UNITED STATES PATENT AND TRADEMARK OFFICE

Office Action Summary

10/816,585

DETAILED ACTION

Fig 1

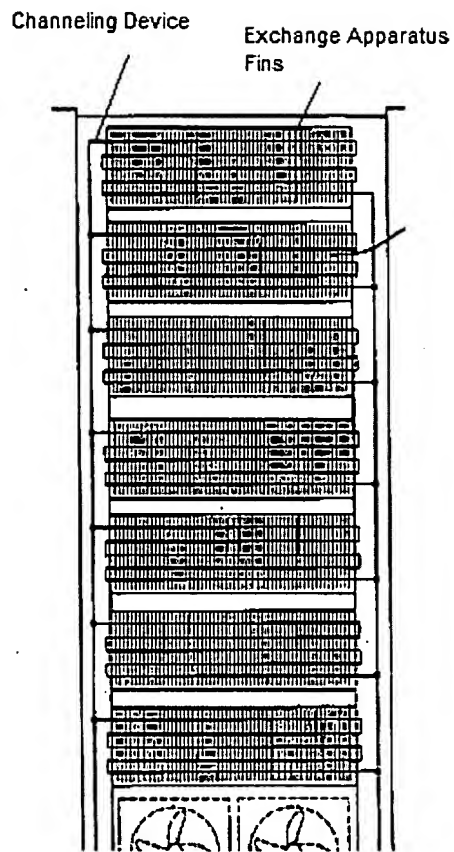
With respect to claim 8, Chu et al. further teaches that each heat exchanger includes a heat exchange fluid channeling device and a heat exchange apparatus in thermal communication with the heat exchange fluid channeling device (See present office action Fig 1 below).

With respect to claim 19, Chu 770 further teaches that the means for cooling air (21) includes a means (As illustrated in the present office action Fig 1 above) for channeling a heat exchange fluid and means (Fins as illustrated in POA Fig 1 above) for channeling the heat exchange fluid extends.

With respect to claim 20, Chu 770 further teaches that the means for heat exchange includes a plurality of heat exchange fins through which the means for channeling the heat exchange fluid extends (As illustrated in POA Fig 1 above).
